HOPE CREEK GENERATING STATION
DOCKET NO. 50-354
DRAFT SAFETY EVALUATION REPORT
OPEN ITEM STATUS

DSEI Open Item No. 222 (DSEI Section 8.2.2.2)

DESIGN PROVISIONS FOR REESTABLISHMENT OF AN OFFSITE POWER SOURCE

WEST AREA
 GENERATING STATION
 FINAL SAFETY ANALYSIS REPORT
 PENETRATION CONDUCTOR
 OVERCURRENT PROTECTION
 FIGURE 402-00-1
 SHEET 200

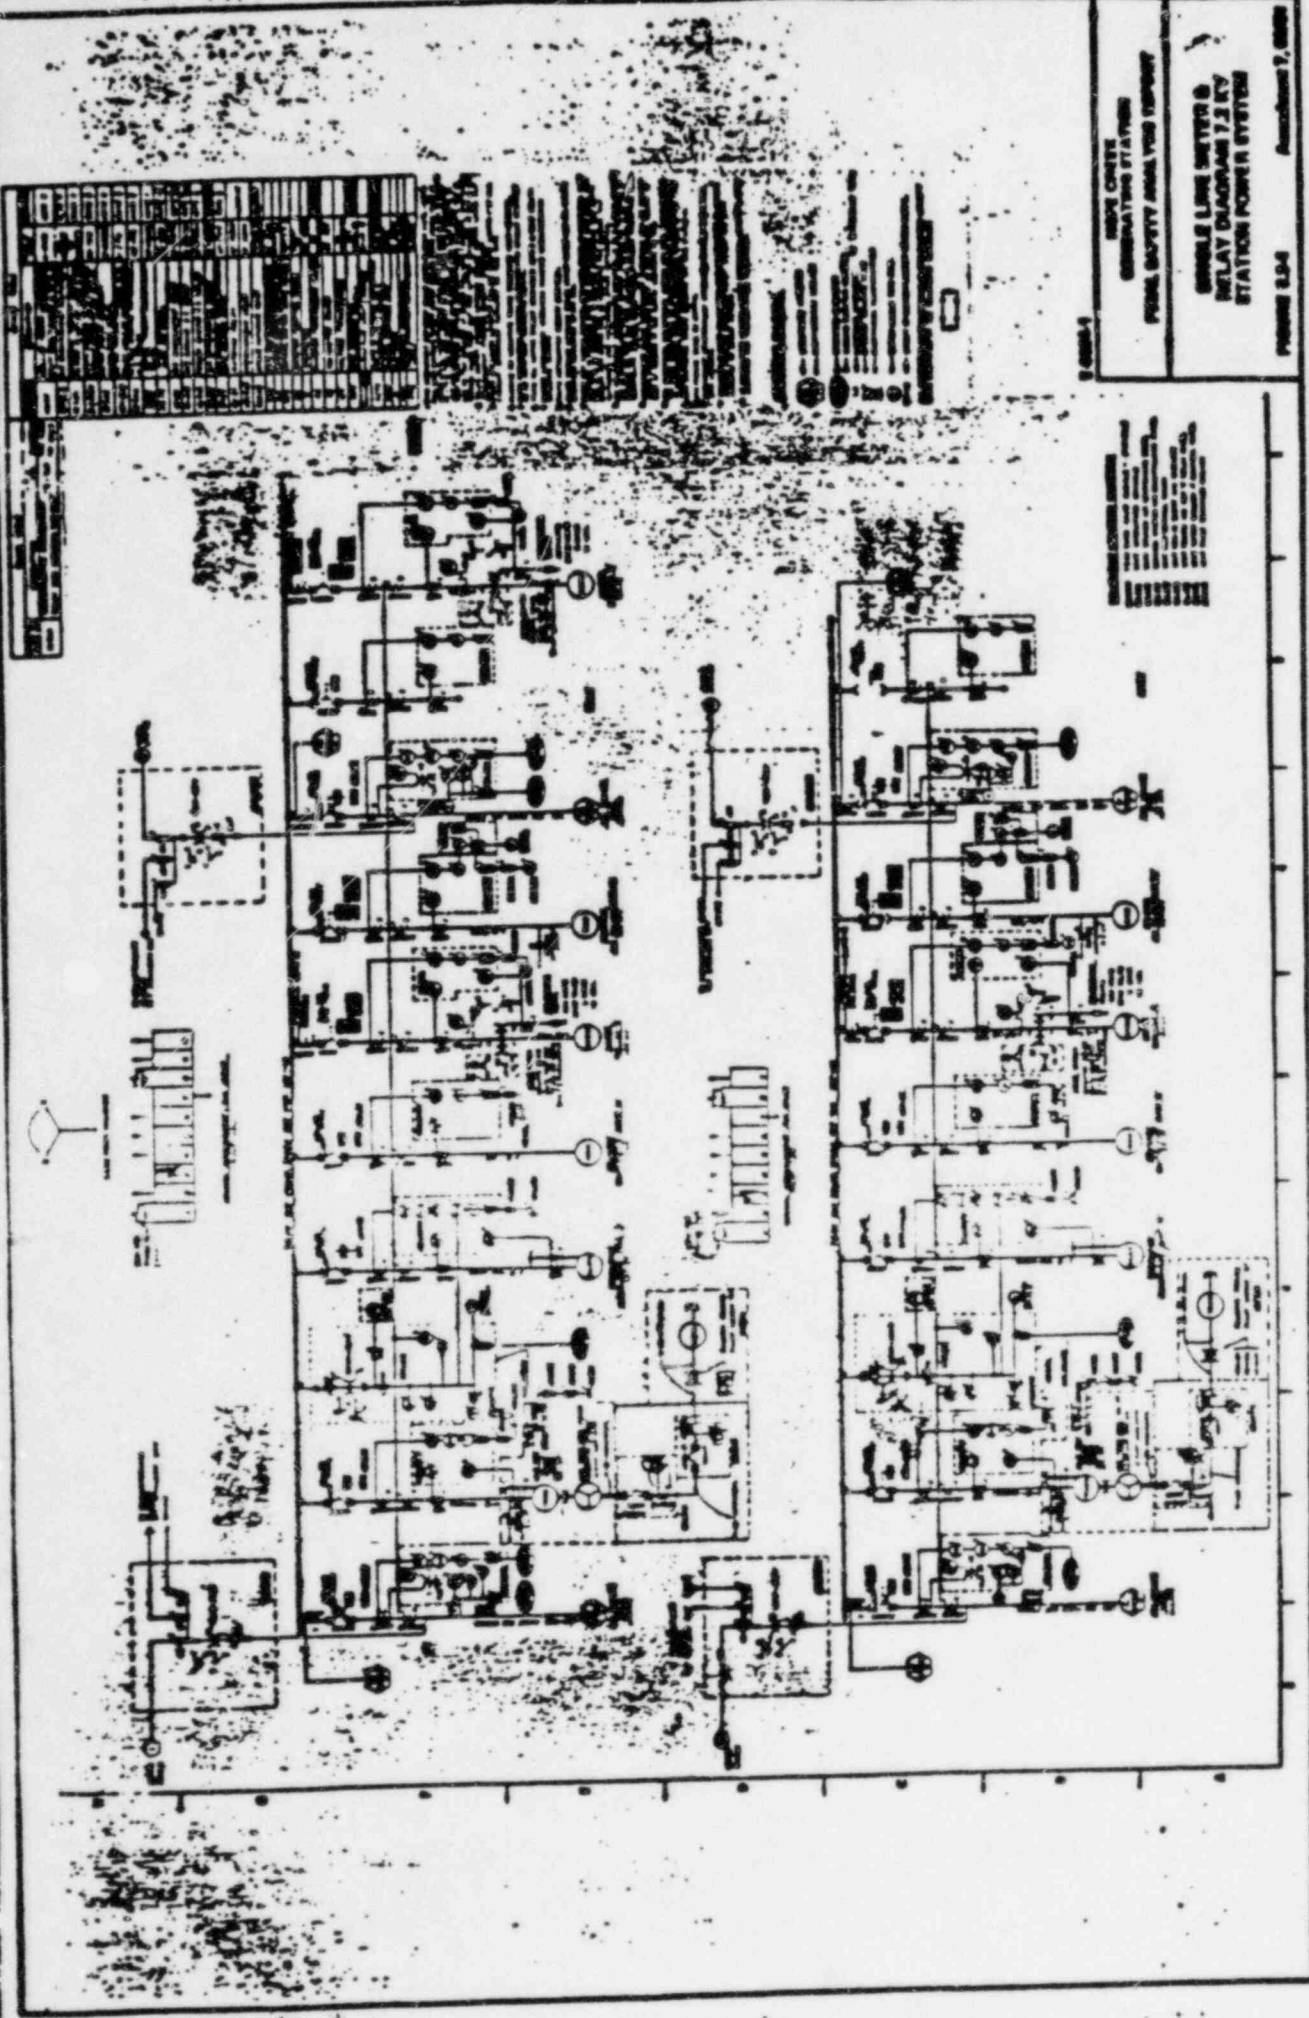
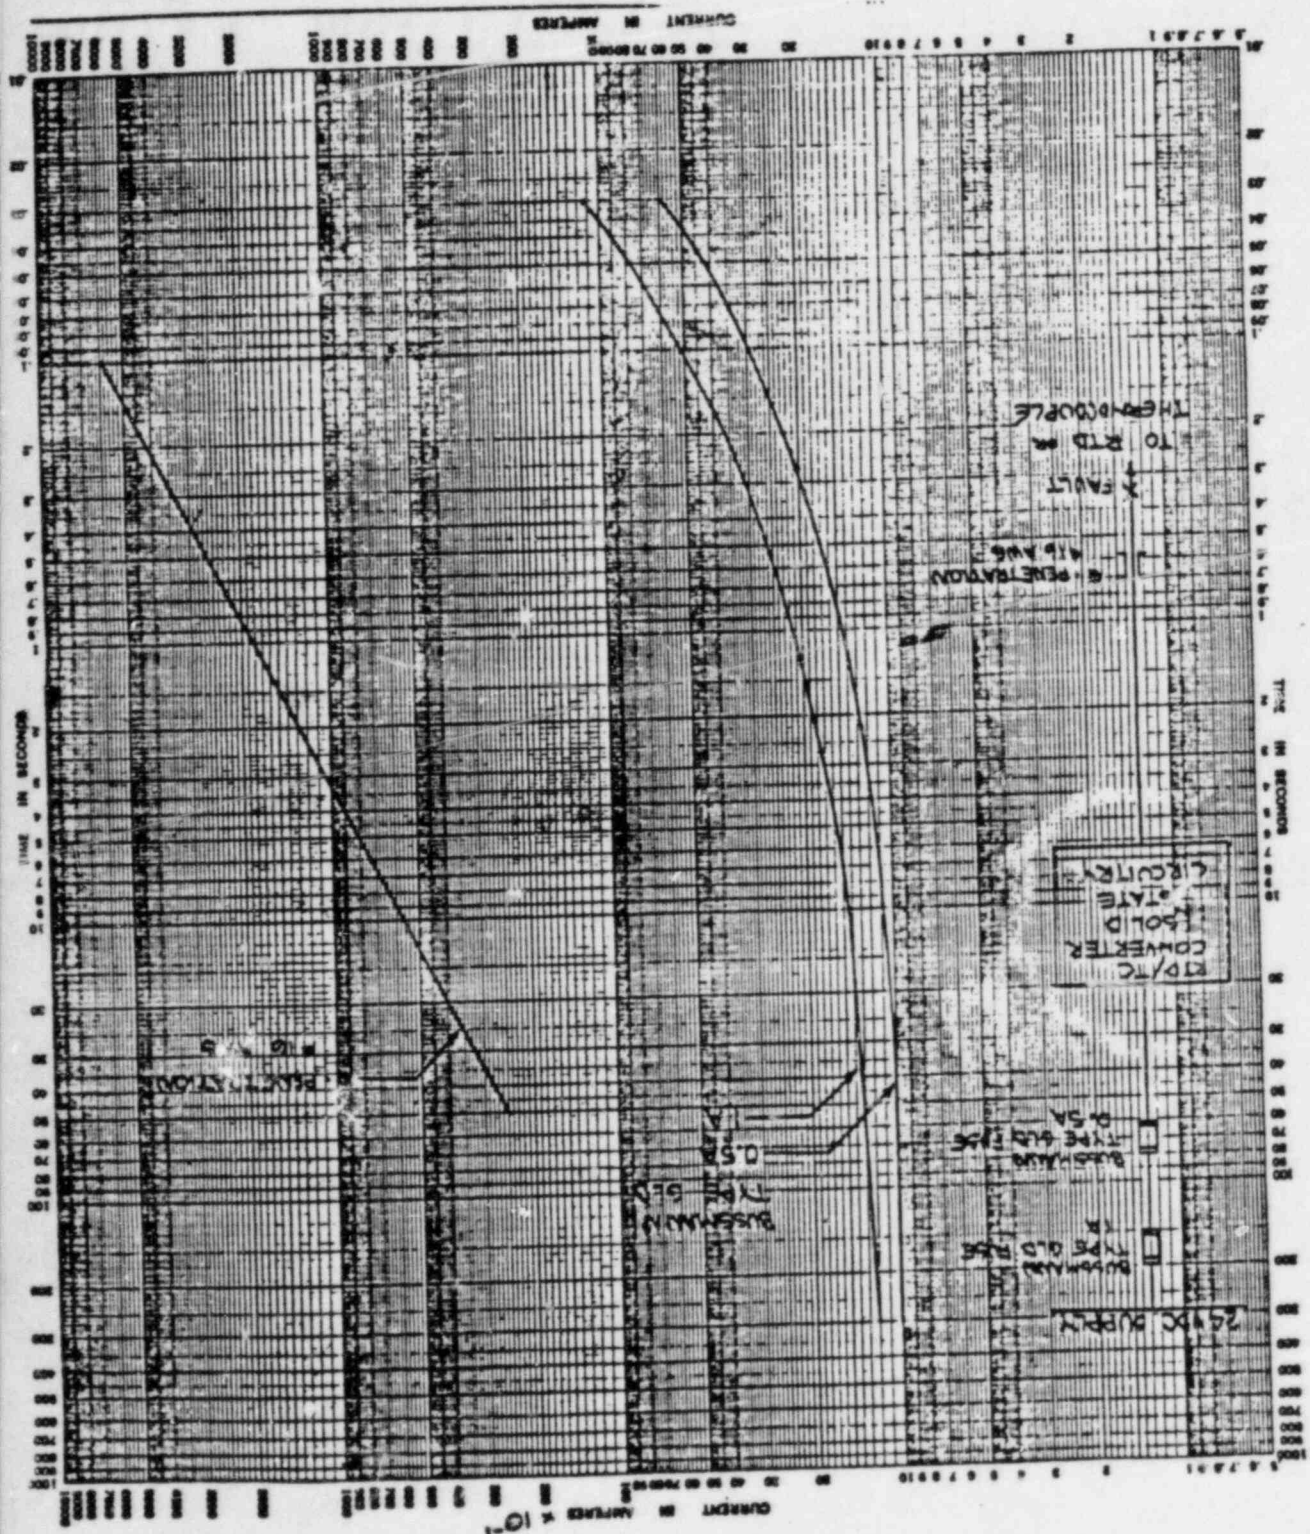
By Amendment 4 to the FSAR, the applicant has indicated that penetration protection for the two reactor recirculation pump motor circuits is provided by a single breaker that is tripped by primary and backup relaying. This design does not meet the requirements of position 1 of Regulatory Guide 1.63. Justification for noncompliance will be pursued with the applicant.

Figure 430.46-1, Sheet 11, of Amendment 7, has been revised to show two breakers.

The only penetrations with instrument class circuits that are protected by a single circuit breaker or fuse are as follows:

The above cases illustrate that the intent of Reg. Guide 1.63 is met. No single failure of a circuit over current protective device could cause a penetration failure. Refer to the representative curves of Figure 430.46-1.
